Office Action Summary

10/634,699

DETAILED ACTION

Fig.4

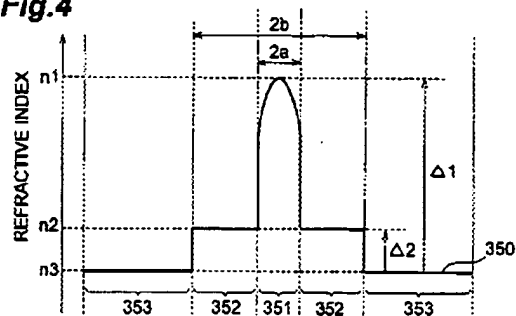
Kato et al teaches a wide-band dispersion controlled optical fiber (column 2 lines 11-17) characterized with the refractive index profile from Fig. 4 and the parameters from Fig. 11 and 12 shown below:

As is shown in the figure and table above (see also column 11 lines 11-64, column 20 lines 18-57 and column 21 line 39 through column 22 line 16) all embodiments (3, 15 and 17) teach dispersion at 1300 nm (O-band) between -12 and -4 ps/nm/km, dispersion at 1600 nm (L-band) between 8 and 14 ps/nm/km and positive dispersion at 1550 nm (C band), effective cross-sectional areas at 1550 nm of less than $75 \mu\text{m}^2$, while embodiments 3 and 15 teach a cut-off wavelength less than 1285 nm, embodiments 3 and 17 teach a zero dispersion wavelength below 1430 nm and embodiments 15 and 17 teach dispersion slopes at the zero dispersion wavelength of less than $0.074 \text{ ps/nm}^2/\text{km}$. Embodiment 3 teaches a bending loss at 1550 nm when wound at a diameter of 32 mm of 0.006 dB per turn, embodiment 15 – 0.00006 dB per turn and embodiment 17 – 0.00002 dB per turn.

All embodiments (3, 15 and 17) teach an internal core with a diameter d_1 (Fig. 4, 2a) (either $6.4 \mu\text{m}$, $4.8 \mu\text{m}$ or $7.5 \mu\text{m}$) and refractive index n_1 (Fig. 4), an external core which encloses the internal core having diameter d_2 (Fig. 4, 2b) (either $16 \mu\text{m}$, $15.1 \mu\text{m}$ or $29 \mu\text{m}$) and refractive index n_2 wherein the refractive index n_2 of the external core gradually decreases from n_1 away from the center of the internal core (cone shaped section, Fig. 4), an internal clad which encloses the external core and has a diameter d_3 (Fig. 4, 353) and refractive index n_3 resulting in d_1/d_2 relationships of 0.4, 0.32 and 0.26 respectively and wherein $n_1 > n_2 > n_3$ and Δ_1 is 0.60%, 0.65%, 0.61% respectively and Δ_2 is 0.10%, 0.06%, 0.10% respectively.
